## **Access Compliance Report Public Rights-of-Way** (Curb Ramps)

Intersection ID: 15907 Main Street: PARK\_RD Cross Street: PARK\_WEST\_DR Location: NW ADA ID: 2195FA9CD052 Ramp Type: PerpDiag Initial Pass/Fail: Fail **Overall Compliance: No Severity Score:** 22.5

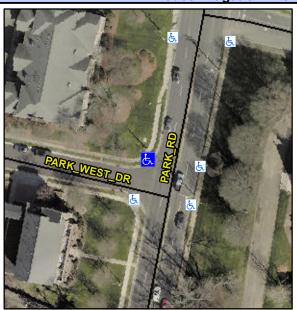
Field Measurements/Component Compliance						
	Compliance Description		Data	Comp	liance Description	Data
	N/A	Ramp Length (in)	48.0	No	Ramp Slope (%)	8.8
	No	Ramp Width (in)	46.0	No	Ramp XSlope (%)	3.2
	N/A	Flare Type LT	N/A	N/A	Flare Type RT	N/A
	N/A	Flare Slope LT (%)	N/A	N/A	Flare Slope RT (%)	N/A
	N/A	Flare Traversable LT?	N/A	N/A	Flare Traversable RT?	N/A
	N/A	Landing Length (in)	N/A	N/A	DWS Provided?	N/A
	N/A	Landing Width (in)	N/A	N/A	DWS Contrast?	N/A
	N/A	Landing Slope (%)	N/A	N/A	DWS Length (in)	N/A
	N/A	Landing X Slope (%)	N/A	N/A	DWS Full Width?	N/A
	N/A	Landing Curb? (Y/N)	N/A	N/A	DWS Offset (in)	N/A
	N/A	Shared Landing?	N/A			
	N/A	Gutter Ponding?	N/A	N/A	Gutter Slope (%)	N/A
	N/A	Gutter Lip Ht (in)	N/A	N/A	Gutter X Slope (%)	N/A
	N/A	Painted X Walk1?	No	N/A	Painted X Walk2?	No
		X Walk 1 Direction	To SW		X Walk 2 Direction	To SE
	N/A	X Walk 1 Width (in)	N/A	N/A	X Walk 2 Width (in)	N/A
		X Walk 1 Slope (%)	4.6		X Walk 2 Slope (%)	3.0

X Walk 1 X Slope (%)	3.4		X Walk 2 X Slope (%)	5.4
	N/A	Ramp inside XWalk1?	N/A	N/A	Ramp inside XWalk2?	N/A
		Road Slope (%)	2.8	N/A	Clear Space?	N/A
		Road X Slope (%)	7.3	N/A	Clear Space to XWalk (in)	N/A
	N/A	Any Obstructions?	N/A	N/A	Storm Grate/Utility Hazard?	N/A
		Obstruction Type			Storm Grate/Utility Type	
			N/A			N/A
				Yes	Surface Condition? (G/P)	Good
		11

Possible Solutions: **Remove & Replace Curb Ramp With** Two New Directional Ramps or Equivalent. Surveyor Notes: N/A PROW/ADA: Not Found, R304.5.1, R304.2.2, R304.5.3
